# Memo

Re: APPROVAL SITE PLAN AND DESIGN REVIEW OF GREEN BAY AREA PUBLIC SCHOOL DISTRICT DOTY ELEMENTARY AT 525 LONGVIEW AVENUE

## Site Plan & Design Review – Staff Comments

**Site:** 525 Longview Avenue (Parcel AL-1385-1)  
**Development:** Green Bay Area Public Schools (GBAPS) - Doty Elementary School  
**Developer Representatives:** GBAPS – Michael Strangel – Executive Director of Facilities and Related Services  
 Architects Group Limited – Carl Winnekins – Project Architect

DOTY SCHOOL  
 EROSION CONTROL PLAN

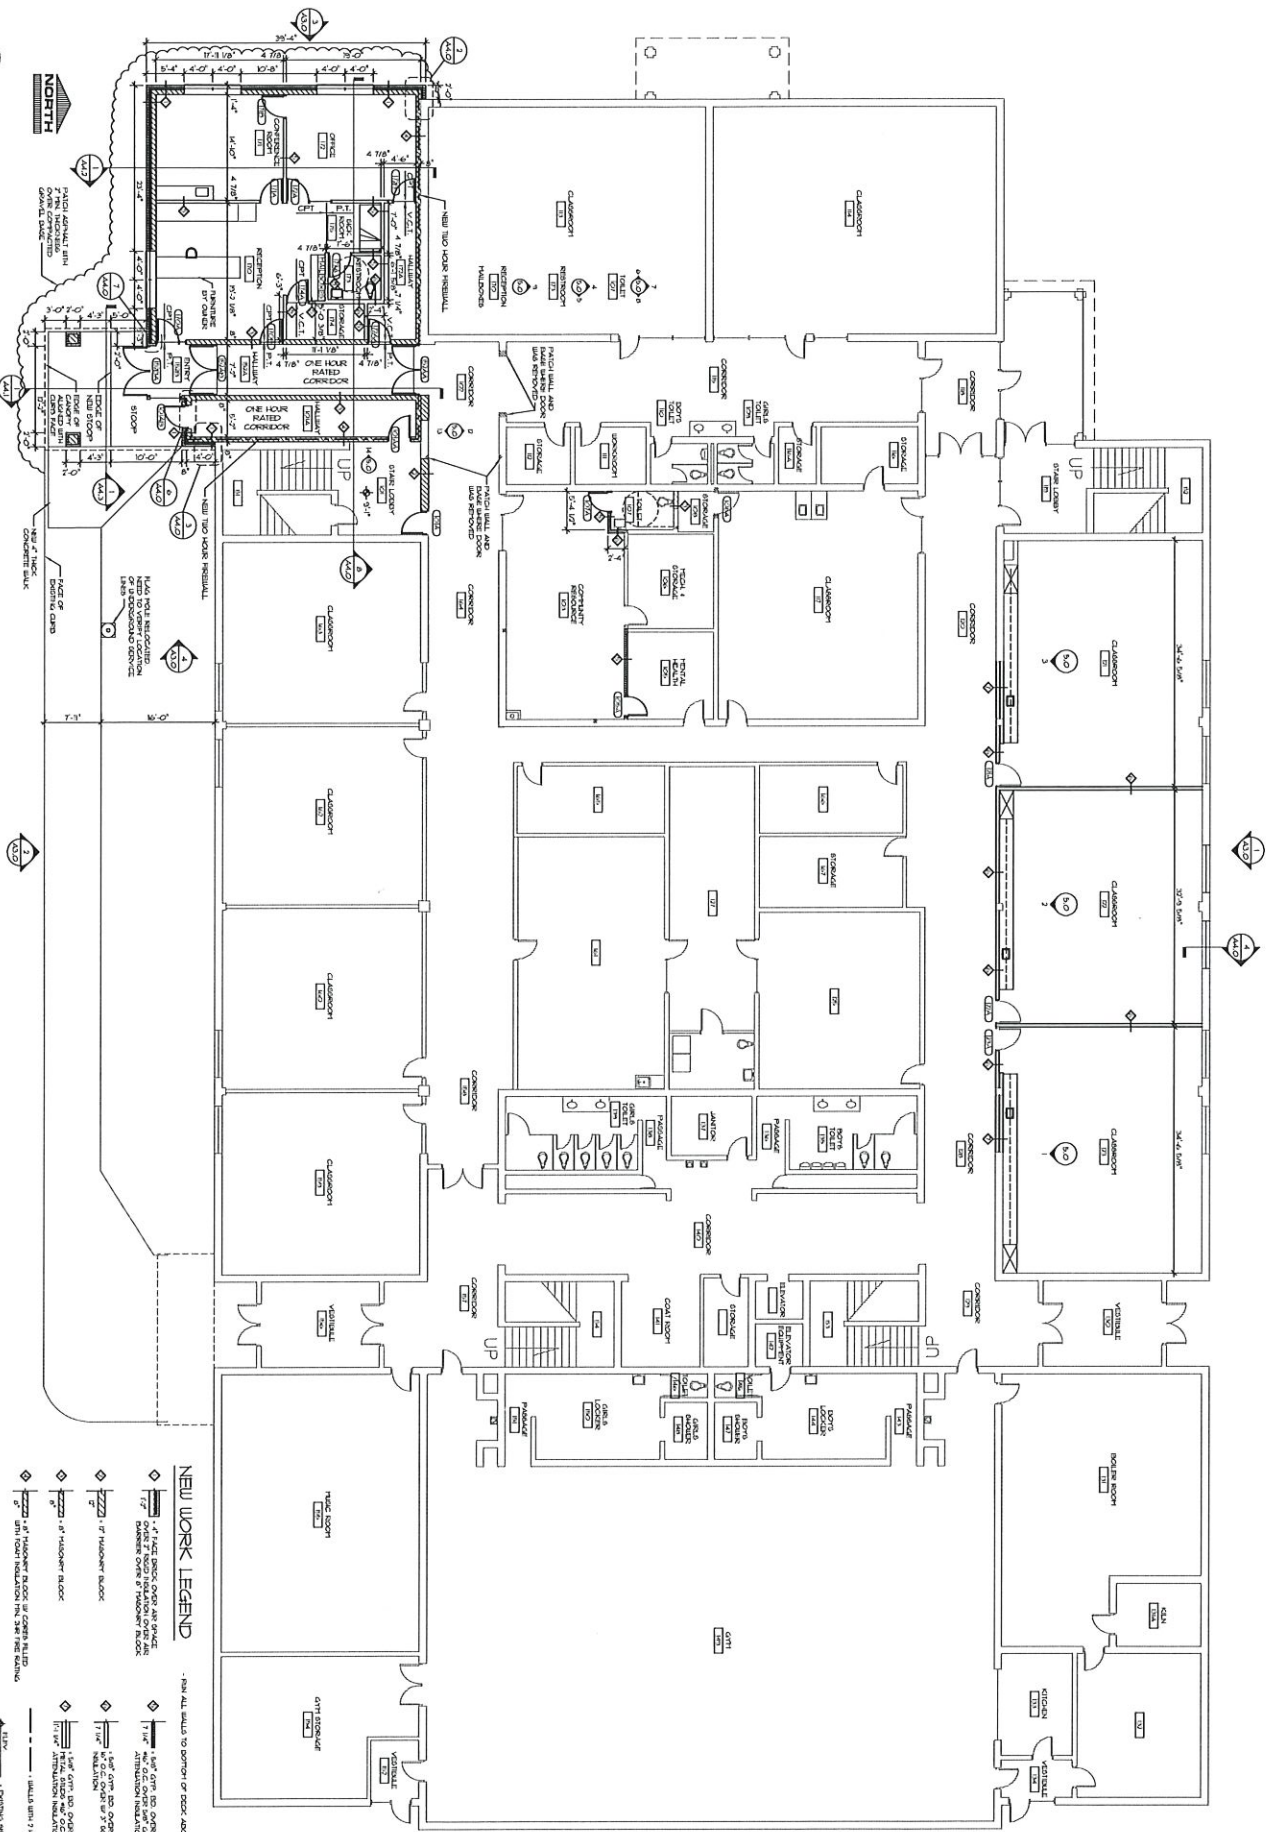
- Fire Department review:
  - Standards met.
- Parks, Recreation, and Forestry Department review:
  - No comment.
- Public Works Department review:
  - All stormwater and erosion control requirements shall be met.

- Construction access – traffic on Longview Avenue shall not be obstructed during construction. Dirt and debris shall be kept on-site and off of the public roadway.
